## Product / Process Change Notification (PCN)

**PCN #:** PCN\_FeSTAR-RING\_20230801

**Affected Series:** STAR-RING; 742715x

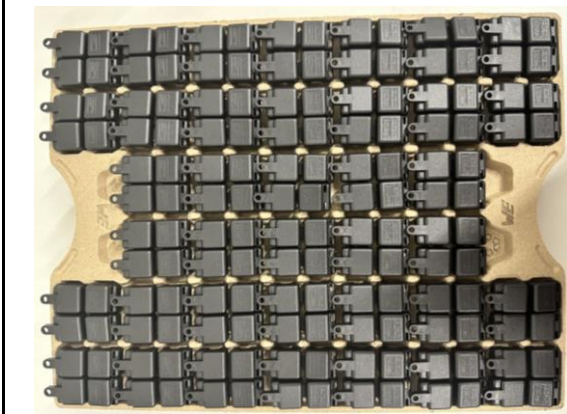
The tray changes in the design and in the size from a double wall corrugated cardboard tray to a paper mould tray. The outer carton size and packaging quantity will change as detailed in the table below. The carton box material will remain double wall corrugated cardboard but changes to a better quality for improved transportation safety.
